**PLANNING AND ZONING COMMISSION  
REGULAR MEETING AGENDA  
MONDAY, OCTOBER 25, 2021, 7:00 PM  
IN-PERSON AT TOWN HALL ANNEX MEETING ROOM, 57 MAIN ST, ELLINGTON, CT  
VIRTUAL ATTENDANCE VIA ZOOM MEETING, INSTRUCTIONS PROVIDED BELOW**

**From:** Dana Steele <dsteale@jrrusso.com>  
**Sent:** Wednesday, October 20, 2021 9:21 AM  
**To:** Lisa Houlihan; Brian Juliano  
**Cc:** John Colonese; Barbra Galovich; jdimeo@julianoassociates.com; Bryan Cormier  
**Subject:** RE: Staff Review - Z202113 100 Windermere Avenue  
**Attachments:** 100 Windermere Ave E&S Bond Estimate Revised 10-20-21.xlsx

I've reviewed the revised plan set and drainage calculations stamped received on 10/12/21. Most of my previous Inland Wetlands (9/16) and PZC (9/17) comments have been addressed. I would note the following:

**Site Plan**

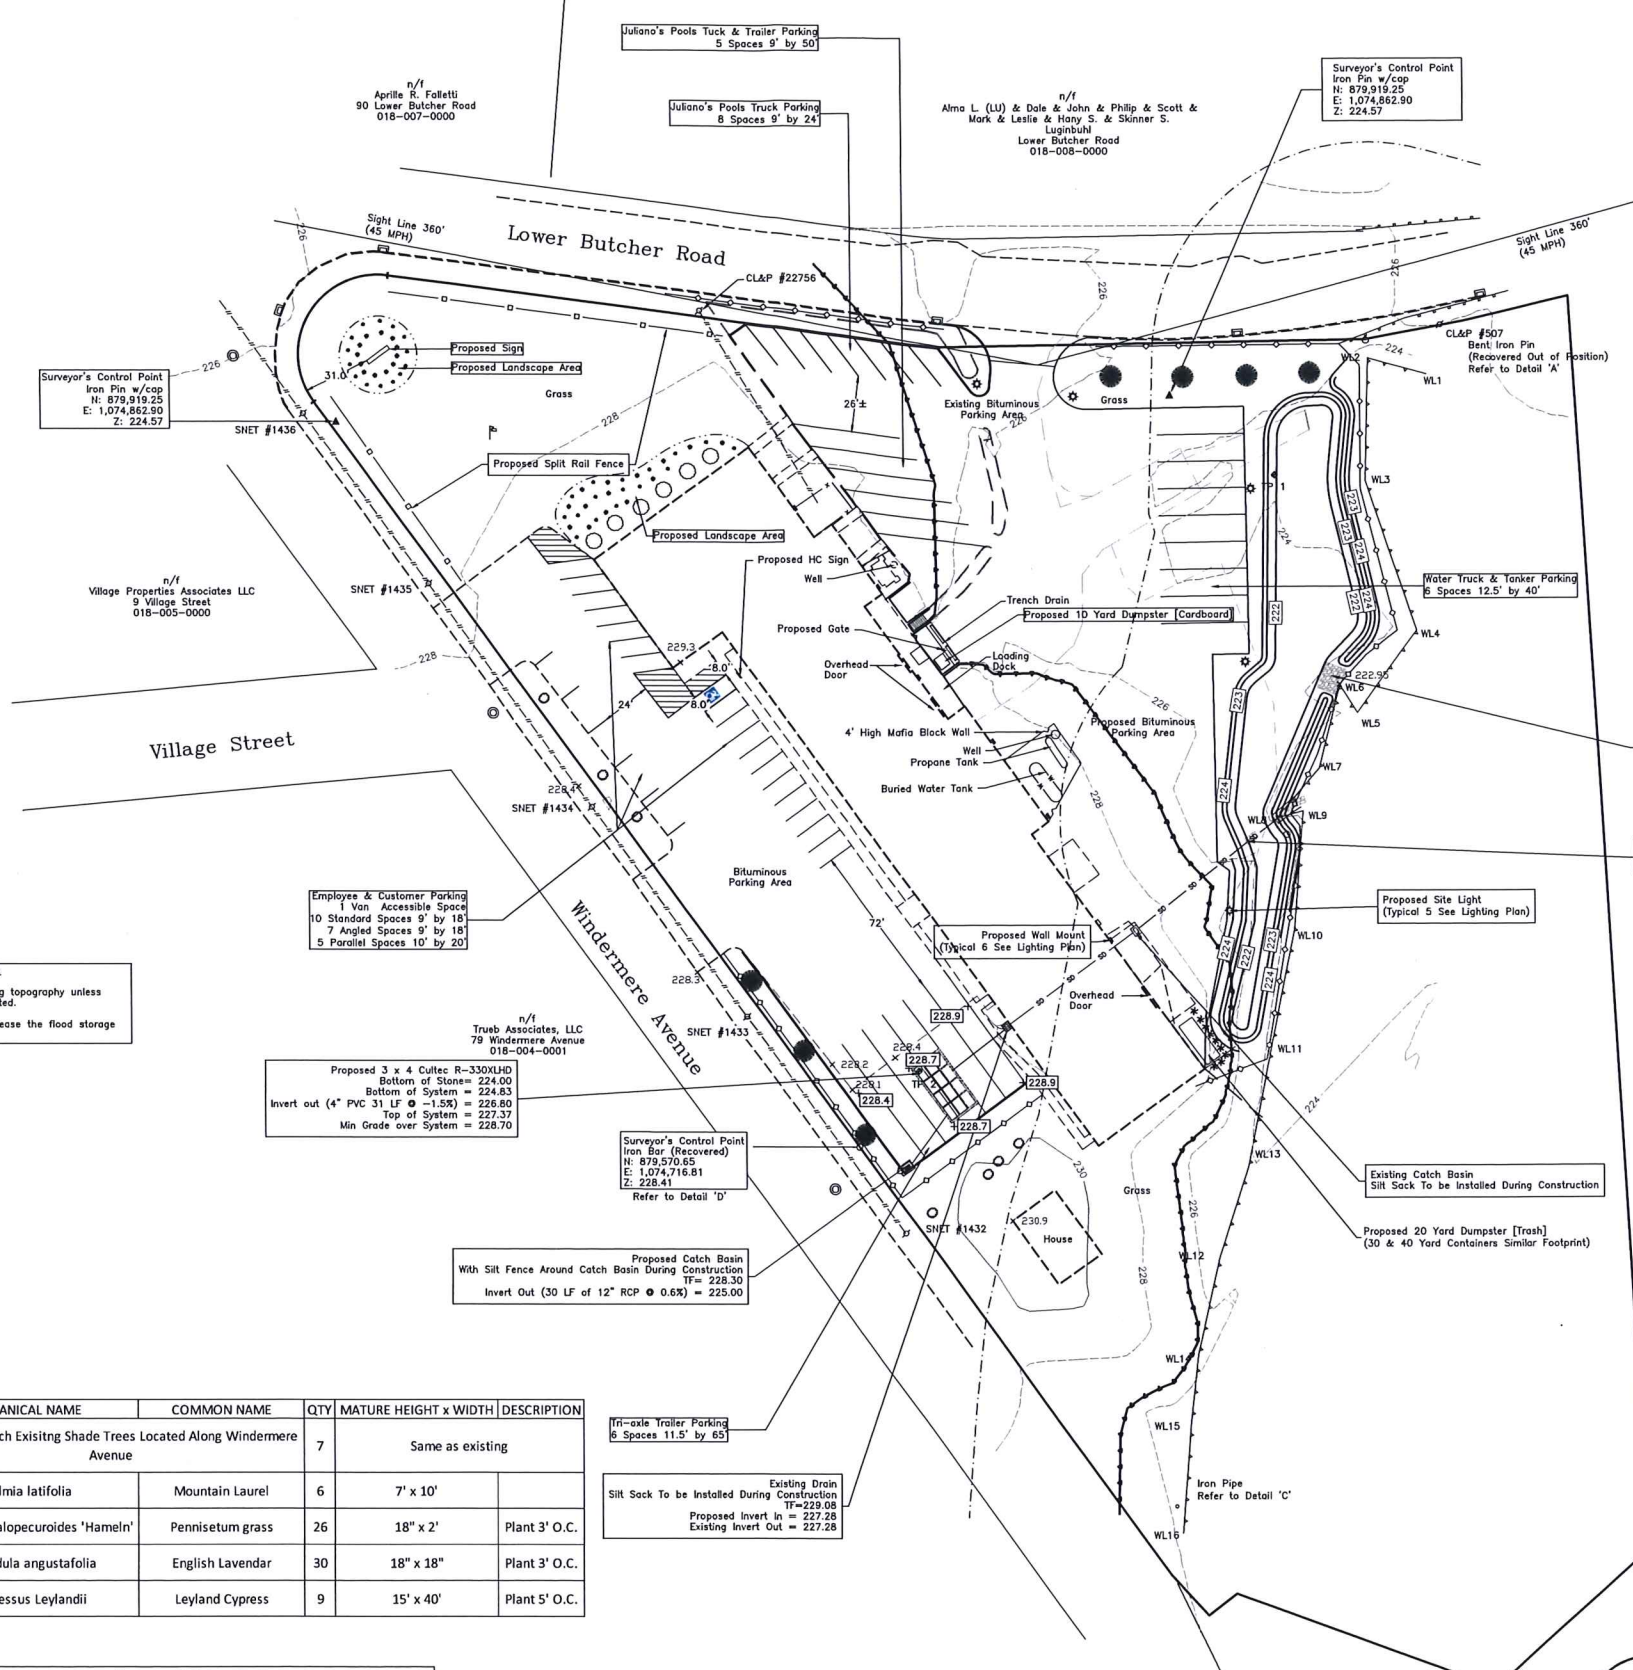
1. The plans still do not indicate the 100-year flood limits per FEMA mapping. There appears to be a line on sheet 2 which perhaps represents the 100-year flood limit, but it is not labeled. The final plans should include a labeled 100-year flood limit on sheets 1 & 2. Note 14 on sheet 1 should be updated.
2. The light poles have been relocated out of the town right-of-way but a revised photometric plan was not included in the plan set. The Commission may elect to defer review of the photometric plan and lighting specifications for staff review.
3. Based on the revised grading plan, I recommend increasing the E&S bond to \$7,000. See attached estimate.
